**MINUTES  
CITY OF LAKEWOOD  
BOARD OF BUILDING STANDARDS/  
ARCHITECTURAL BOARD OF REVIEW/SIGN REVIEW  
FEBRUARY 13, 2020 at 5:30 P.M.  
LAKEWOOD CITY HALL  
AUDITORIUM**

**ARCHITECTURAL BOARD OF REVIEW**

**16000 and 15801 Detroit Avenue  
Market Rate Apartments**

Barry-Solove Development  
 Enlargement A  
 1.27.2020

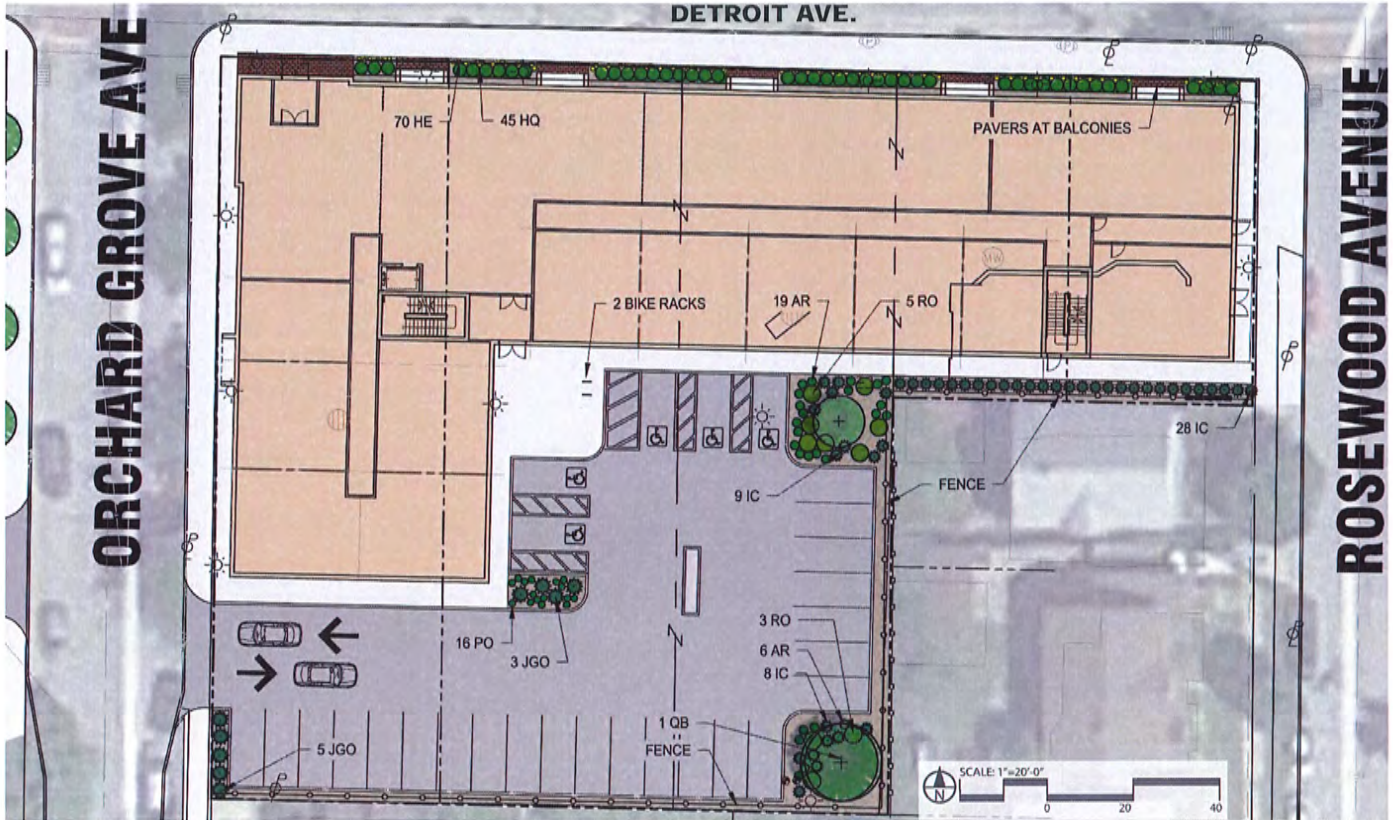
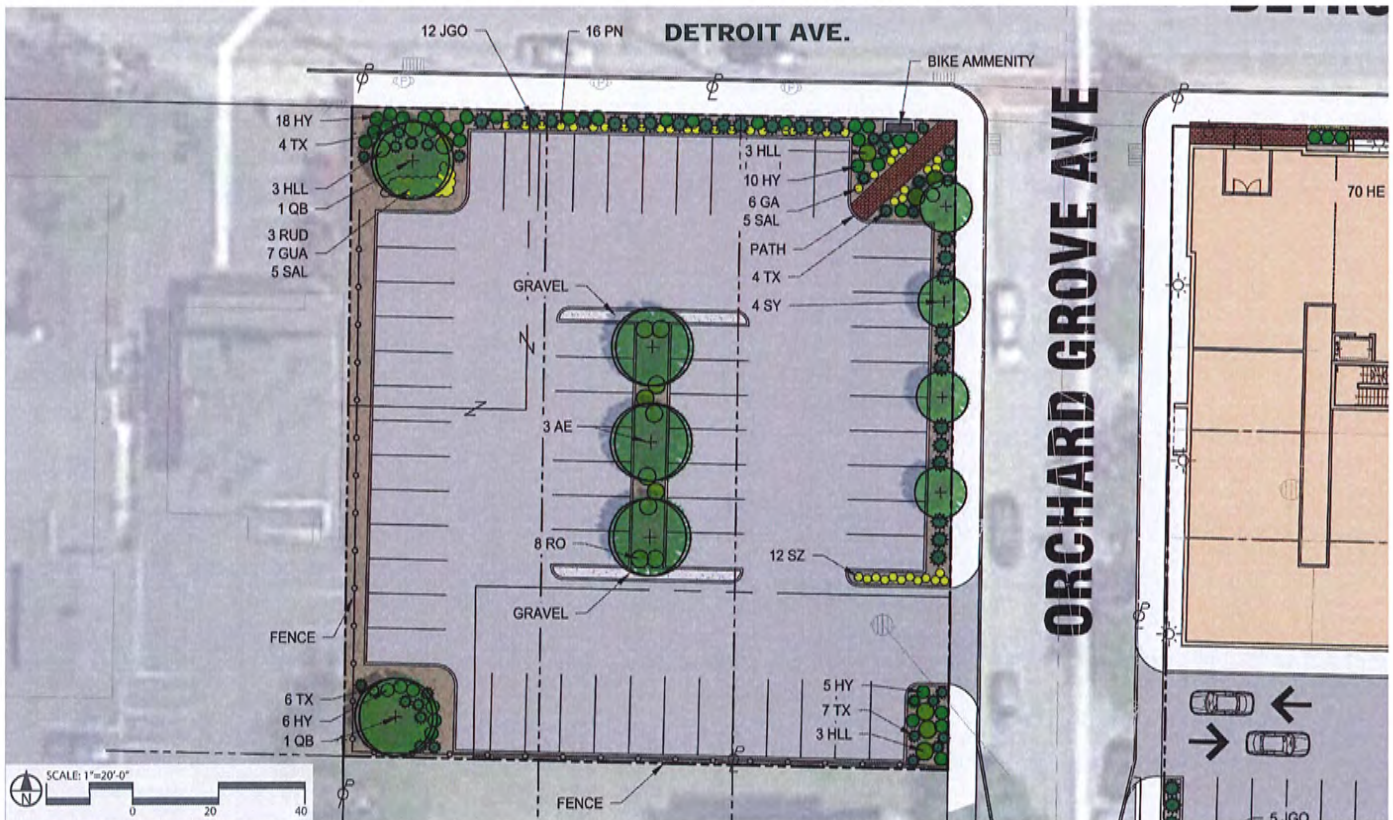
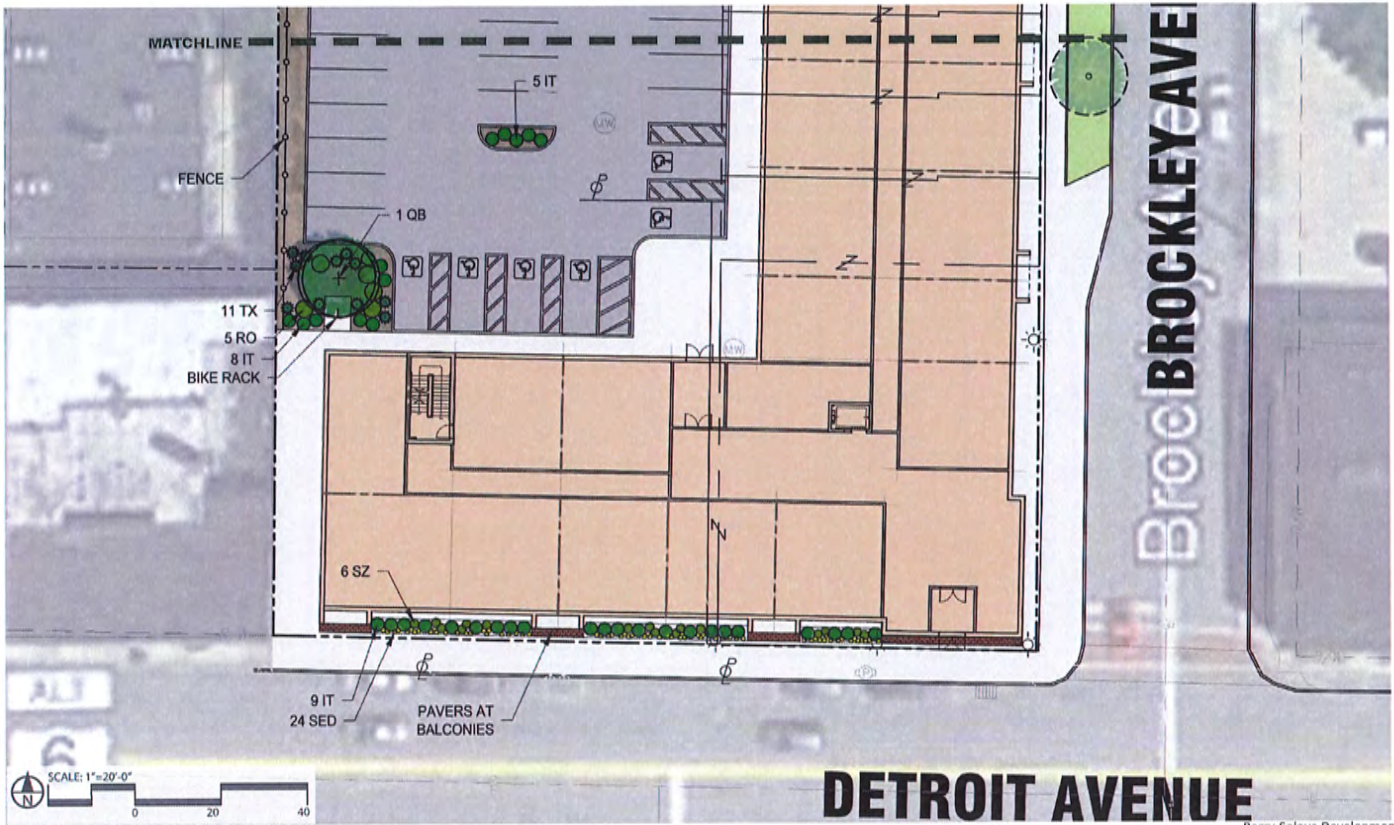
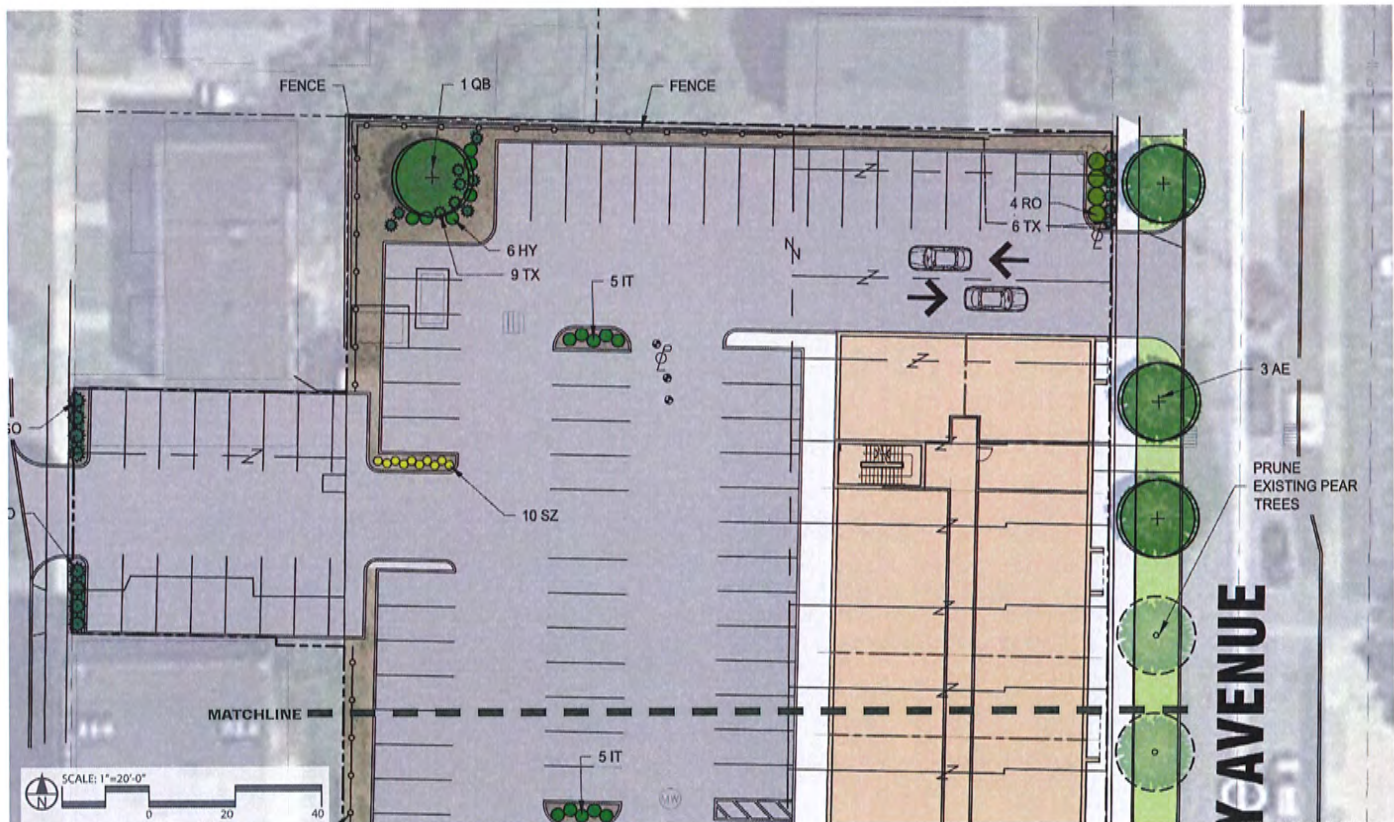
- Provide more detail on the parking lot edges, setbacks, and screening of abutting residential properties.
- Consider enhancing the landscaping/innovative design of the Detroit & Orchard Grove parking lot, including the addition of street trees along the Detroit side of lot.
- More detail on parking lot striping/circulation – show plan to deconflict pedestrians and vehicles, especially at lot entry from Brockley on north end of northern building.
- More detail on design of alley between northern building and existing building on Detroit
- Requested to look at adding more bicycle parking and other streetscape amenities.
- Show proposed building/parking lot fixtures and how light will be arranged to produce the desired effect but also as to not unduly impact abutting residential properties (per Code Sections 1325.08f and 1306.311).

- Demonstrate adherence to 1325.08 (Parking Lot Design) by providing a lighting and fencing plan regarding abutting residential properties.
